City of Franklin

Meeting Agenda

Tuesday, January 8, 2019

15. [18-1099](#) PUBLIC HEARING: Consideration Of Resolution 2018-96 - A Resolution Approving A Development Plan For The Fields At Reese Farm PUD Subdivision For The Property Located North Of Del Rio Pike And West Of Reese Drive, 2970 Del Rio Pike. (12/20/18 FMPC 6-2; 1/08/19 WS)

**131. Sidewalk Access in Open Space**

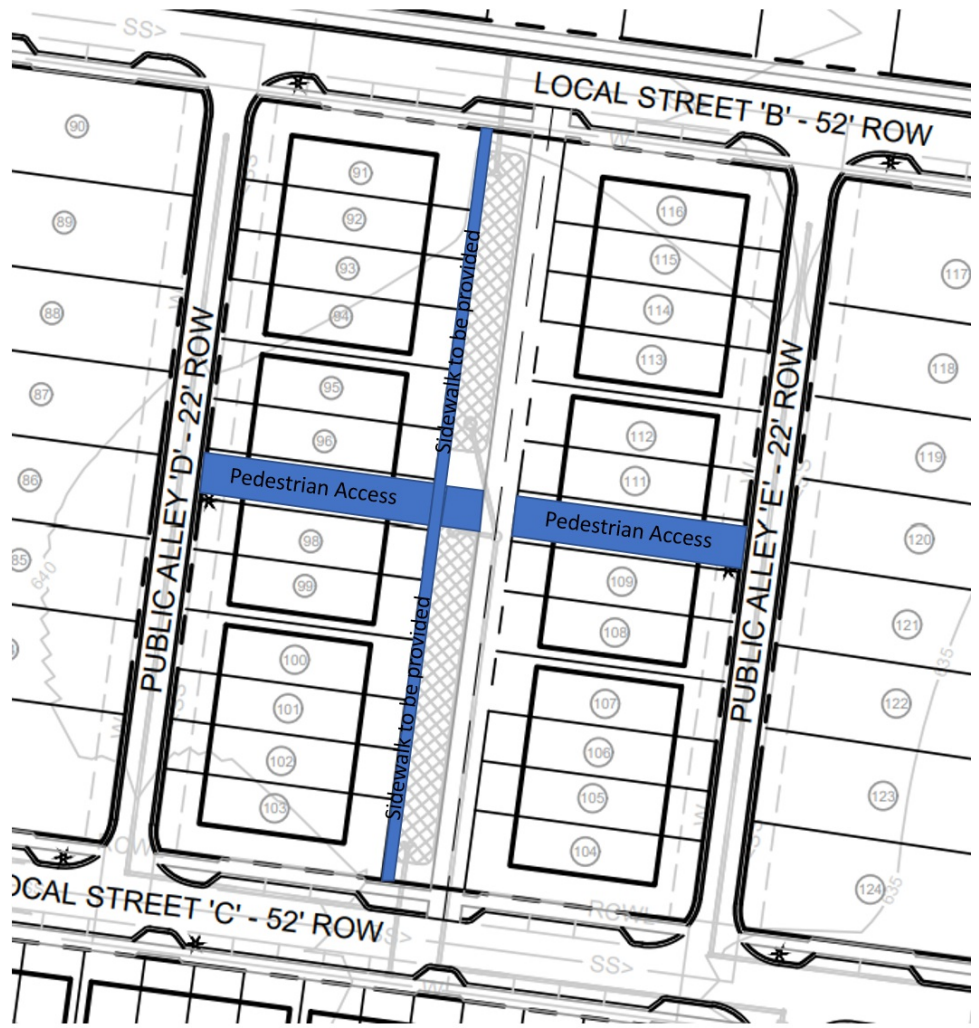
christopher.andrews@franklinton.gov Sidewalks shall be added to both sides of the rectangular open space in the northern portion of the development depicted below, which runs primarily north to south, and where townhouses front from both sides; and that pedestrian access be provided, running generally east to west, in between the proposed row of townhouses. The applicant recognized that as a result of this condition, a reduction in the number of buildable lots may occur.

132. Lot Number for Open Space

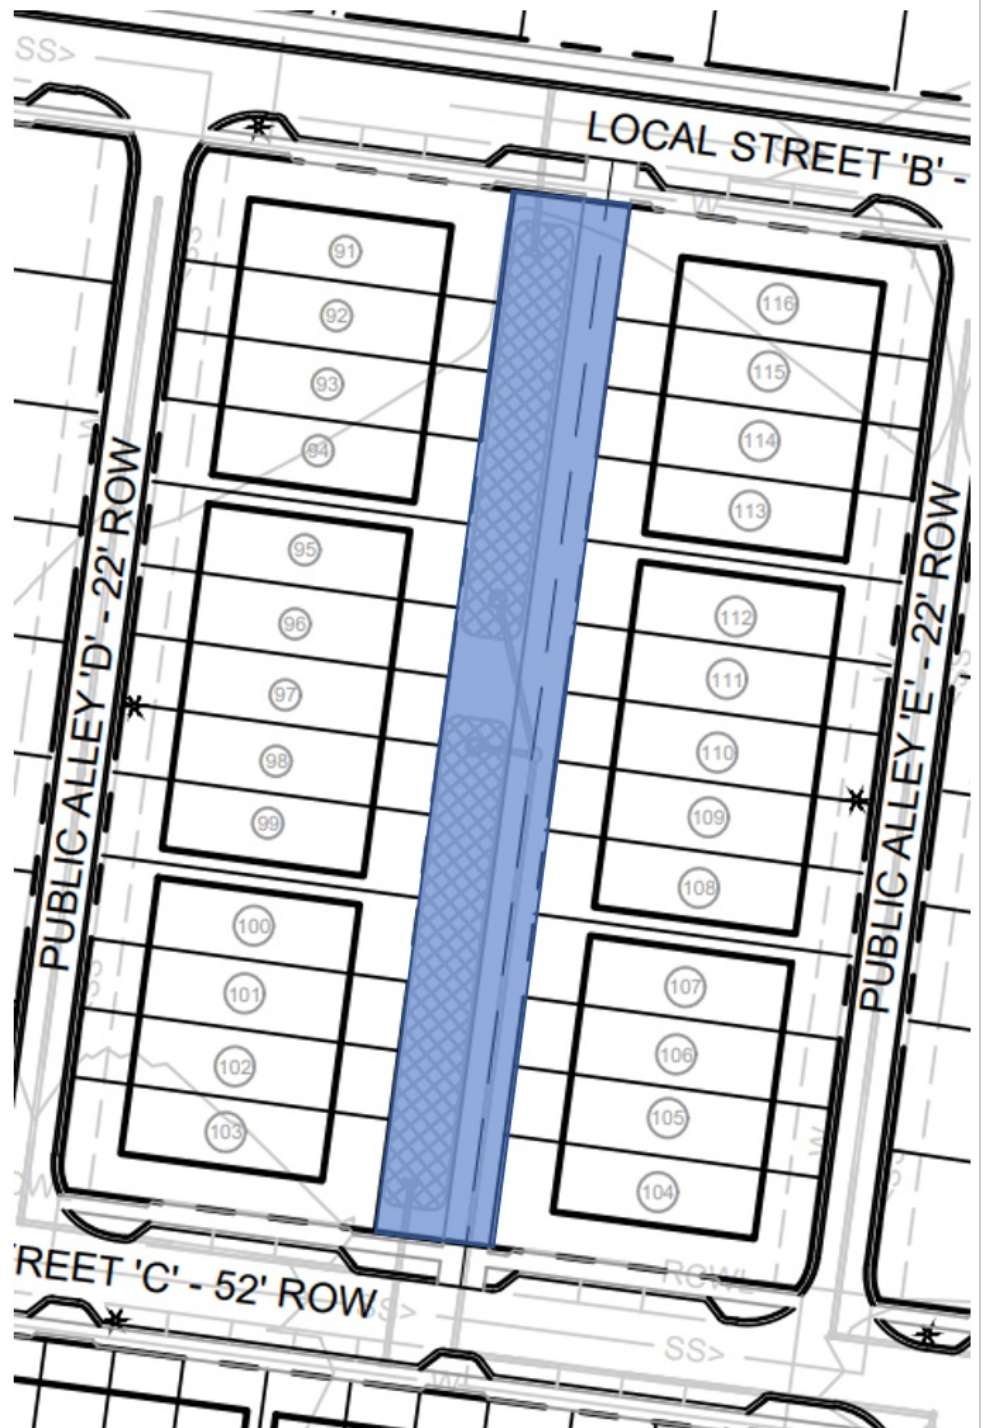
christopher.andrews@franklinton.gov Please provide a lot number for the linear open space shown below:

133. Lots Fronting Open Space / Stream

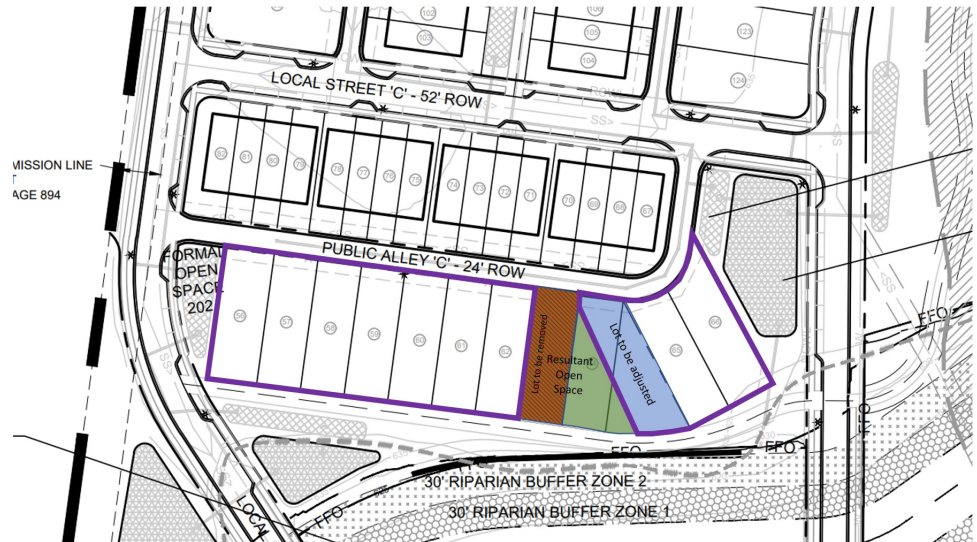
christopher.andrews@franklintn.gov Lots with frontage along the open space containing the stream and that take rear access from proposed "Alley C" as labelled on the development plan shall be modified. Removal of Lot 63 as currently labelled on the development plan, along with the shifting of Lot 64 to be adjacent to Lot 65 helps to satisfy staff concerns related to addressing. Changes to the block layout shall be representative of the depiction below. The applicant recognizes that these changes may lead to the loss of buildable lots.

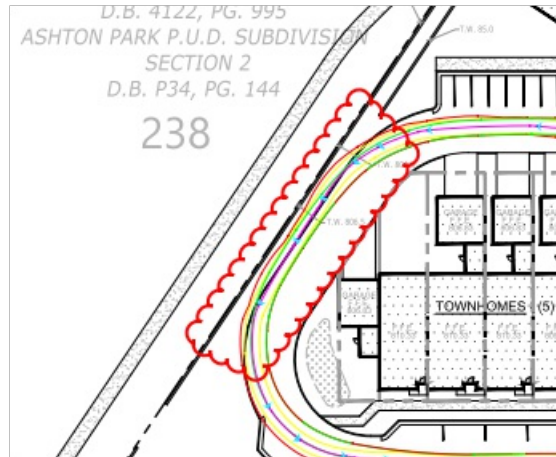
Applicant to correct the Autoturn on C4.17 such that the apparatus wheels are always on pavement.

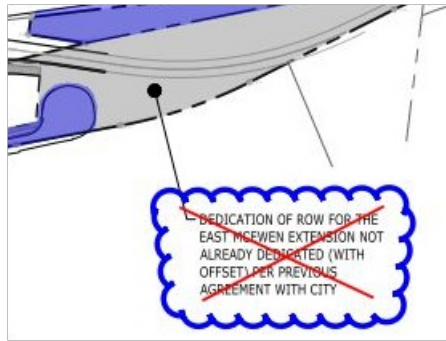
2. Show 'Future ROW' extending 2 feet beyond back of curb at the existing cul-de-sac in Garden Club Court. (C4.0, 4.15)

3. Remove note clouded below, and remove dedicated ROW between the cul-de-sac and that needed for the McEwen Extension. (C4.0, 4.14)

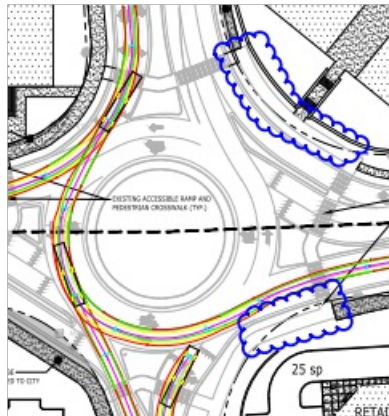
4. Show 'Future ROW' for the 12 feet needed for the additional lane at the south leg of the roundabout, per the TIA review. (C4.0, 4.14)

5. Show "Future ROW" for the sidewalks clouded below at the E. McEwen Drive / Cool Springs Blvd Intersection. (C4.14)

140. Gas Line Easement

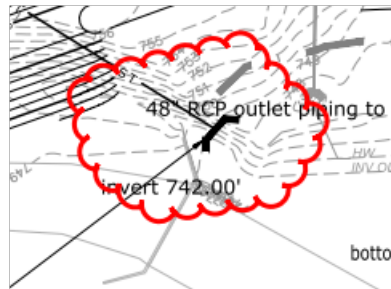
joe.marlo@franklin.tn.gov The gas line has been shown to be relocated to be within Garden Club Court. The following is an Advisory Comment, **but does not hinder approval of the Development Plan.**

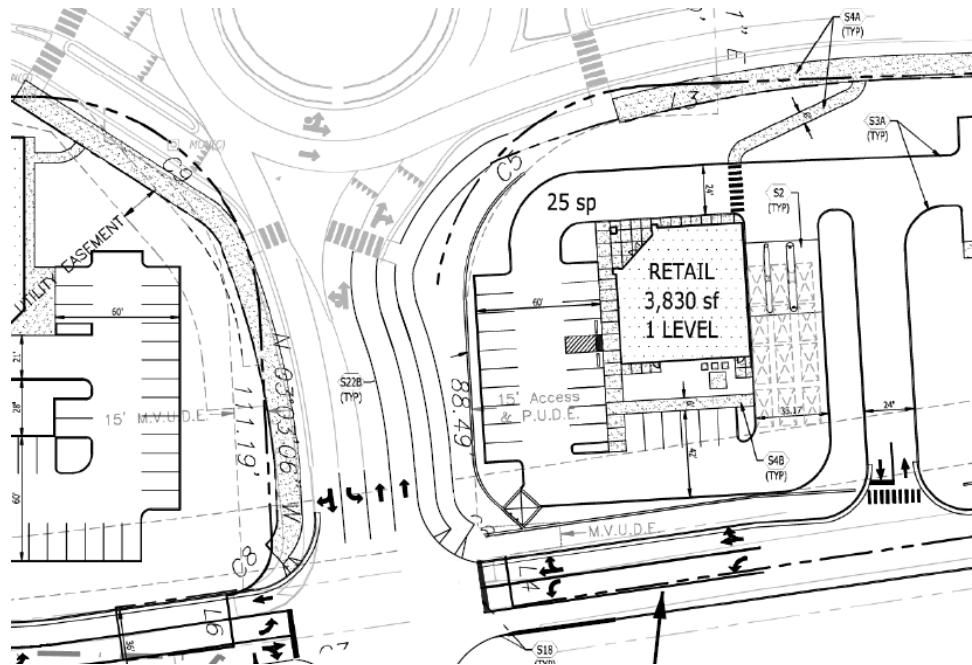
At the Site Plan stage, Applicant to shift the proposed junction box clouded below to be out of the turn lane. (C3.13). Additionally, the 54" RCP should be directed to discharge more parallel to the retaining walls adjacent to the bioretention areas instead of perpendicular, as schematically shown in the sketch above.

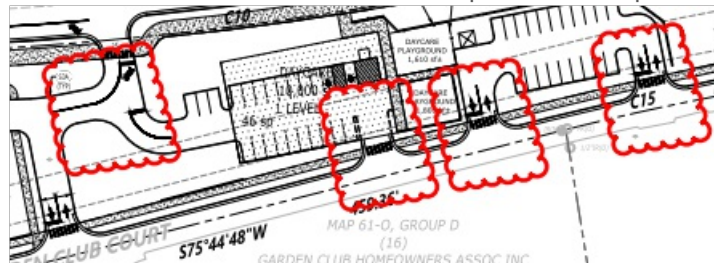
Advisory Comment: At Site Plan, the Applicant will be required to revise the drives and accesses clouded below to meet Street Specification requirements. (C2.15)

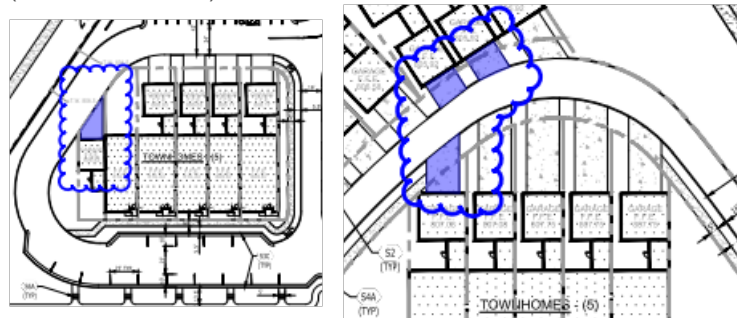
Advisory Comment: At Site Plan, the Applicant will be required to revise driveways such that all portions of driveway lengths are either 5 feet or less, or 20 feet or more, from the edge of pavement to the face of garage, including those highlighted below. (C2.17 and C2.18)

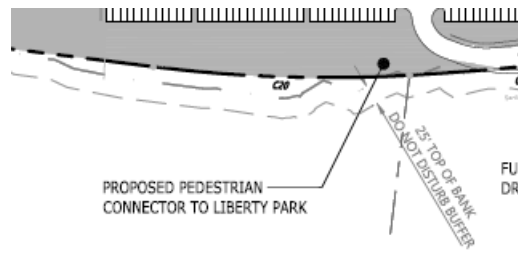
There is still a reference to the connection on page C2.0. Please remove the comment.
